Clause 47 Report

Comment Resolution

XAUI Return Loss

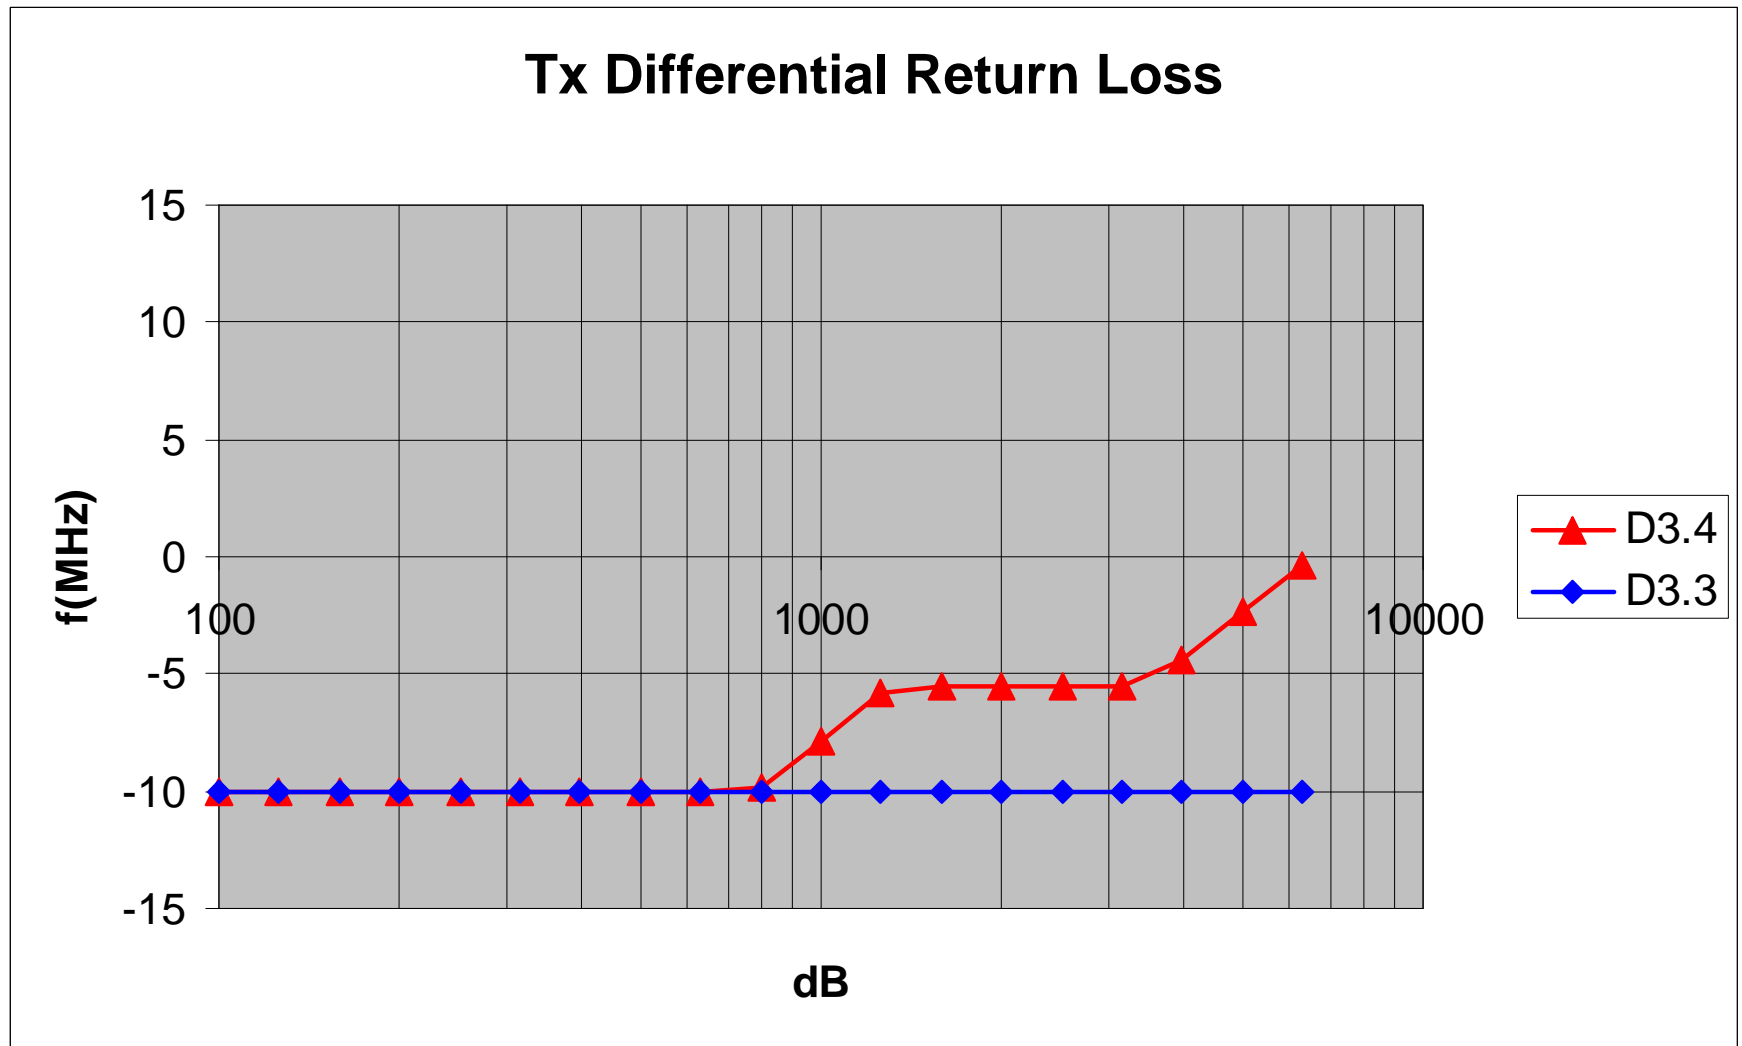
- Resolved all 9 comments
- 4 TRs, 3 from D3.1, 1 new in support of old TR
 - #99007: XAUI Tx Differential Return Loss
 - #3 in agreement with #99007
 - Agreement that a problem exists at formal CL47 session
 - Suggested remedy accepted as interim solution
 - Shawn Rogers, TI and Tom Gray, Tality subsequently provided “improved” solution. See next slides.
 - Commenter reached by phone. Agreement to resolution.
 - #99008 & 99009: XAUI Random Jitter
 - No additional support for comment
 - Rejected again (third time)
